Condominium Plat (Conversion)
East Hailey Meadows
Conversion of an existing Multi-family structure to
Condominiums

STAFF REPORT

TO: Hailey Planning and Zoning Commission
FROM: Micah Austin, Community Development Director
RE: Preliminary Plat – East Hailey Meadows Condominiums (Conversion)
HEARING: November 10, 2014

Applicant: Tony Ehrenberg and Thomas A. Ehrenberg Living Trust, represented by Bruce Smith of Alpine Enterprises
Project: East Hailey Meadows Condominium Conversion
Request: Preliminary Plat approval with recommendation to the City Council
Location: Lot 6, East Hailey Meadows
Zoning: Limited Residential (LR) within the Townsite Overlay (TO)

A PRELIMINARY PLAT SHOWING
EAST HAILEY MEADOWS CONDOMINIUMS
 WITHIN S9, T.2N., R.18E., B.M., CITY OF HAILEY, BLAINE COUNTY, IDAHO
 PREPARED FOR TONY EHRENBERG

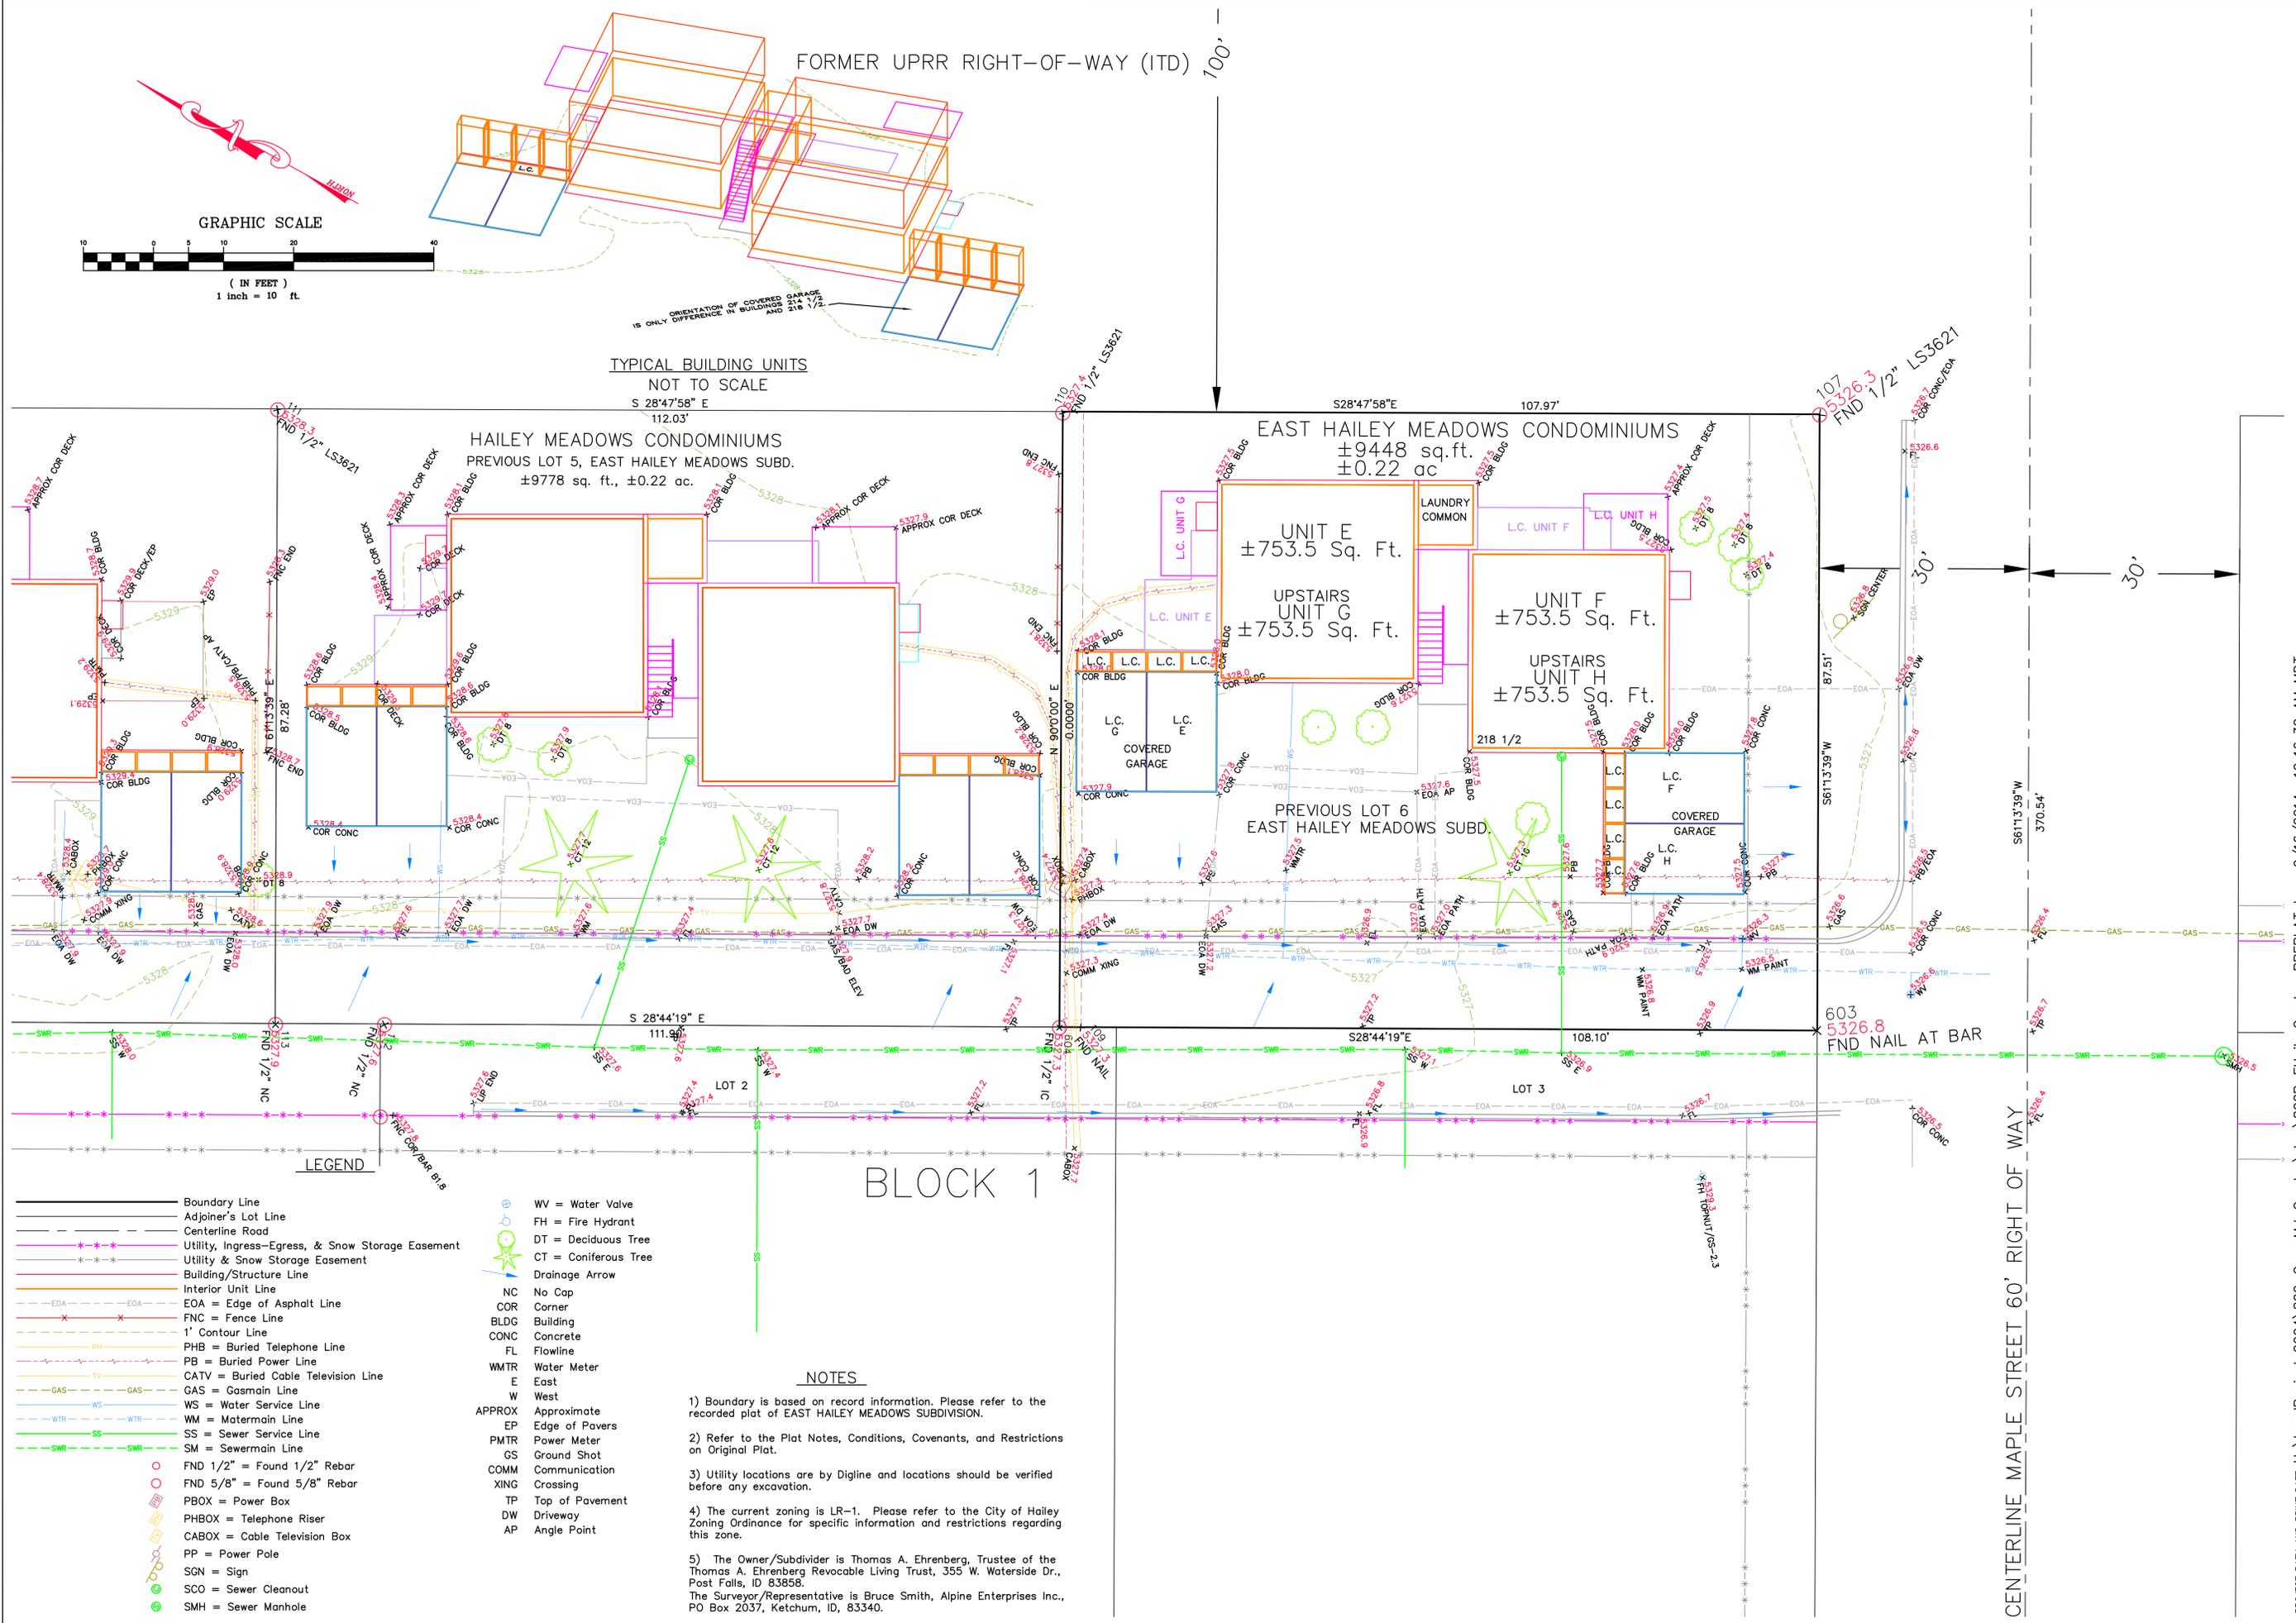
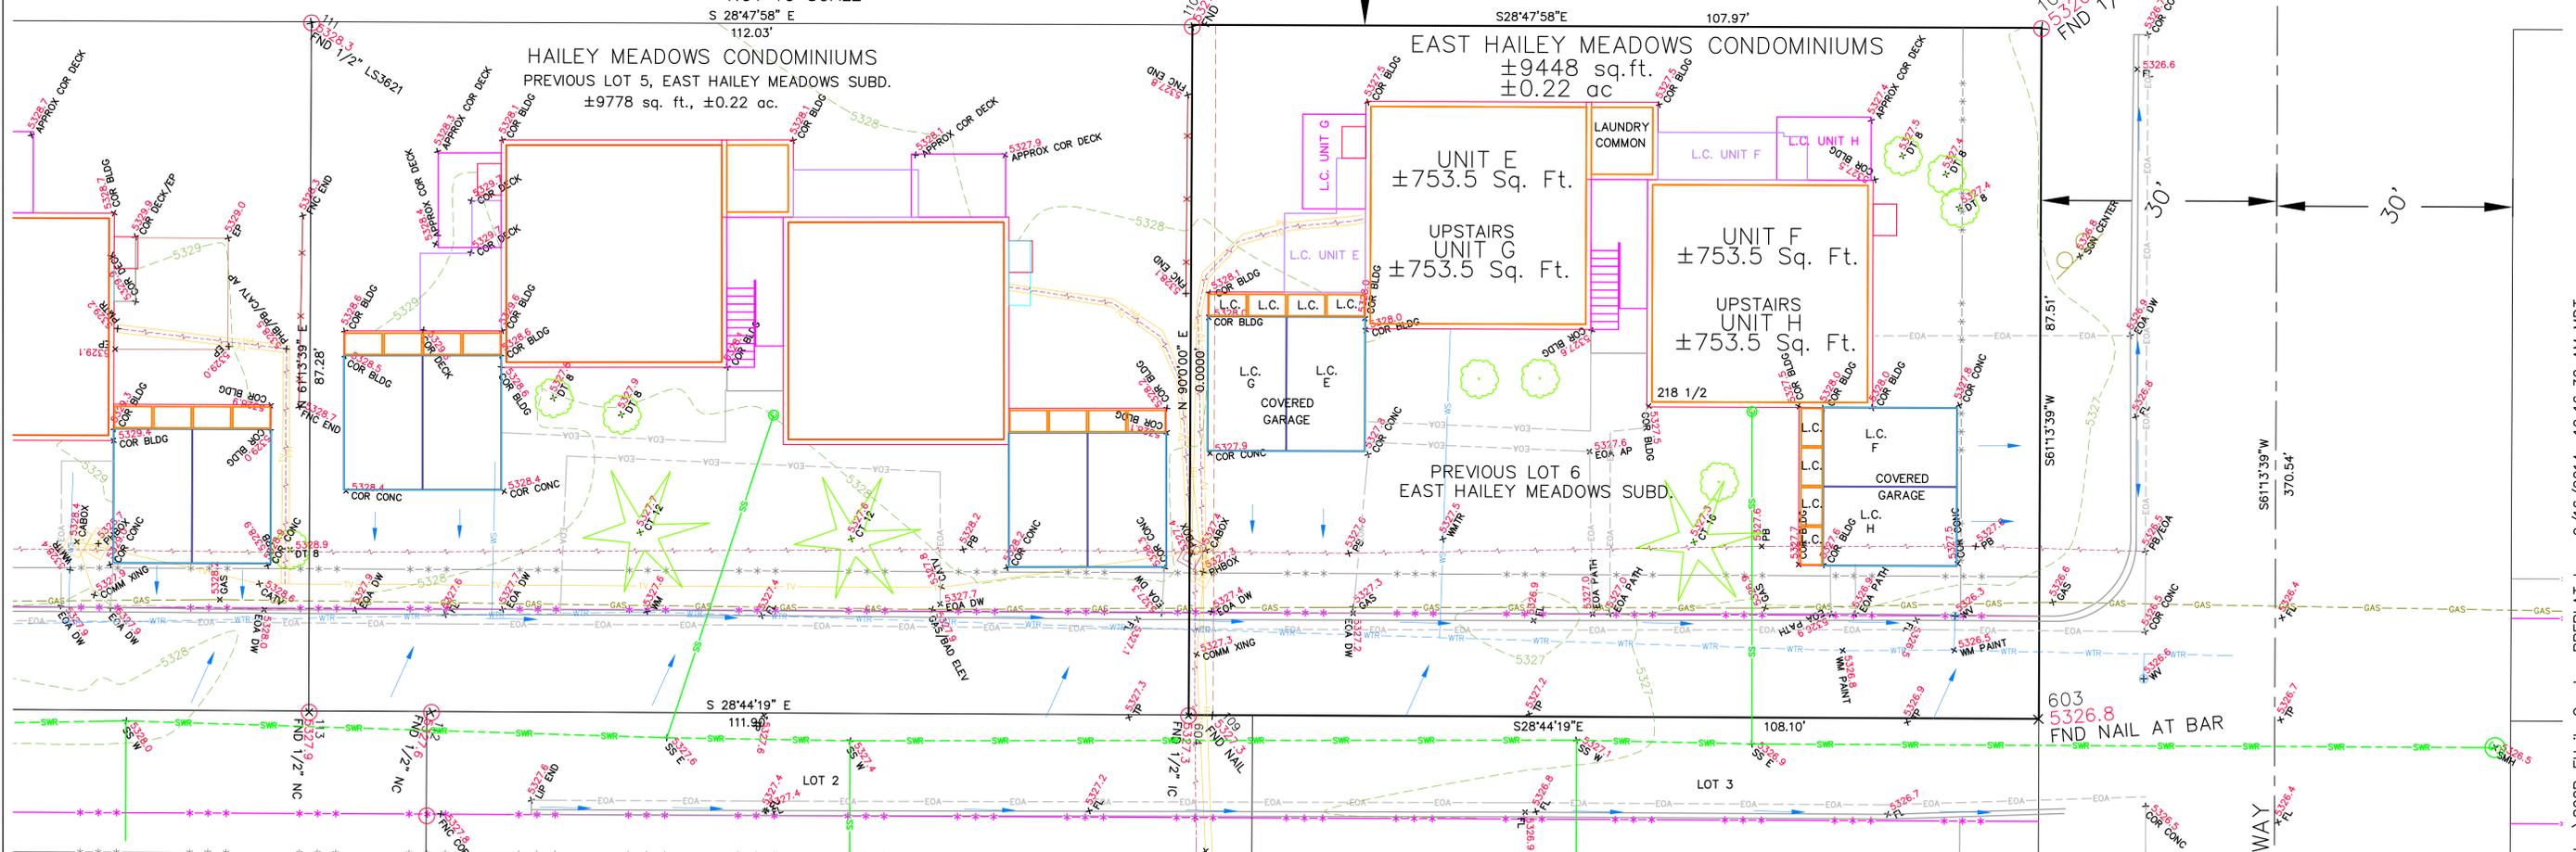
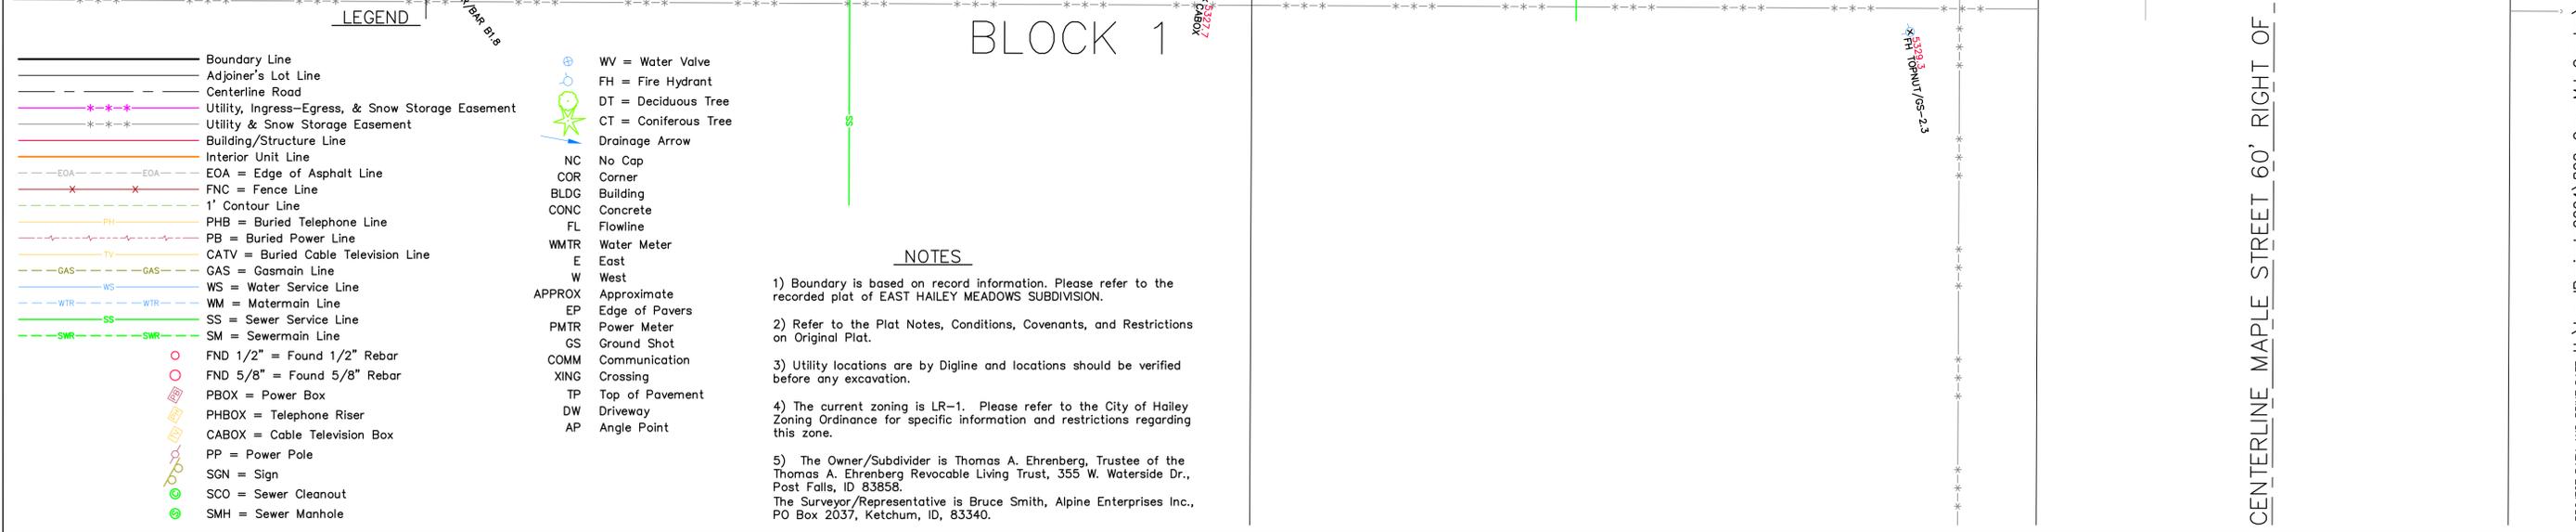
Staff Comments	- An existing easement provides for a private access drive and currently services the building. This is considered a non-conforming use; however the proposed preliminary plat complies with the provisions of Article 13 of the Zoning Ordinance.
<input checked="" type="checkbox"/>	<input type="checkbox"/>	<input type="checkbox"/>	4.1.10.2	Private streets, wherever possible, shall provide interconnection with other public streets and private streets.
			Staff Comments	- The existing private access drive connect Maple and Chestnut Streets.
<input checked="" type="checkbox"/>	<input type="checkbox"/>	<input type="checkbox"/>	4.1.10.3	The area designated for private streets shall be platted as a separate parcel according to subsection 4.5.3 below. The plat shall clearly indicate that the parcel is unbuildable except for public vehicular and public pedestrian access and ingress/egress, utilities or as otherwise specified on the plat.

<i>Staff Comments</i>	- A current driveway easement provides access to the units and is shown on the current final plat.
<input checked="" type="checkbox"/>	<input type="checkbox"/>	<input type="checkbox"/>	4.3.8.1	To provide access through or to any property for the purpose of providing utilities, emergency services, public access, private access, recreation, deliveries or such other purpose. Any subdivision that borders on the Big Wood River shall dedicate a 20-foot wide fisherman's access easement, measured from the Mean High Water Mark, which shall provide for non-motorized public access. Additionally, in appropriate areas, an easement providing non-motorized public access through the subdivision to the river shall be required as a sportsman's access.
			<i>Staff Comments</i>	- The condominium declaration and bylaws address all common areas for utility access.
<input checked="" type="checkbox"/>	<input type="checkbox"/>	<input type="checkbox"/>	4.3.8.2	To provide protection from or buffering for any natural resource, riparian area, hazardous area, or other limitation or amenity on, under, or over the land. Any subdivision that borders on the Big Wood River shall dedicate a one hundred (100) foot wide riparian setback easement, measured from the Mean High Water Mark, upon which no permanent structure shall be built, in order to protect the natural vegetation and wildlife along the river bank and to protect structures from damage or loss due to river bank erosion. A twenty-five (25) foot wide riparian setback easement shall be dedicated adjacent to tributaries of the Big Wood River. Removal and maintenance of live or dead vegetation within the riparian setback easement is controlled by the applicable bulk requirement of the Flood Hazard Overlay District. The riparian setback easement shall be fenced off during any construction on the property.

<i>Staff Comments</i>	- Not applicable
<input checked="" type="checkbox"/>	<input type="checkbox"/>	<input type="checkbox"/>	4.3.8.3	To provide for the storage of snow, drainage areas or the conduct of irrigation waters. Snow storage areas shall be not less than twenty-five percent (25%) of parking, sidewalk and other circulation areas. No dimension of any snow storage area may be less than 10 feet. All snow storage areas shall be accessible and shall not be located over any above ground utilities, such as transformers.
			<i>Staff Comments</i>	- Required snow storage area is 250 square feet to accommodate all impermeable surfaces. - Two snow storage areas are provided with approximately 450 square feet in each.

<i>Staff Comments</i>	- The applicant has submitted a copy of the proposed by-laws and condominium declarations, which provide for the control and maintenance of all common utilities, common areas, facilities, and open spaces.
<input checked="" type="checkbox"/>	<input type="checkbox"/>	<input type="checkbox"/>	7.2	<p>Garages. All garages shall be designated on the preliminary and final plats and on all deeds as part of the particular condominium units. Detached garages may be platted on separate sub-lots, provided that the ownership of detached garages is appurtenant to specific condominium units on the condominium plat and that the detached garage(s) may not be sold and/or owned separate from any dwelling unit(s) within the condominium project.</p>
			<i>Staff Comments</i>	- Garages and driveways are shown on the plat.
<input checked="" type="checkbox"/>	<input type="checkbox"/>	<input type="checkbox"/>	7.3	<p>Storage/Parking Areas. Condominium projects shall provide parking spaces according to the requirements of Article IX of the Zoning Ordinance.</p>

- a) All Fire Department and Building Department requirements shall be met.
- b) All City infrastructure requirements shall be met as outlined in the Hailey Subdivision Ordinance and further detailed in the Findings of Fact as approved. Detailed plans for all infrastructure to be installed or improved at or adjacent to the site shall be submitted for Department approval and shall meet City Standards where required. Infrastructure to be completed at the applicant's sole expense and shall include all infrastructure improvements as identified in the Findings of Fact.
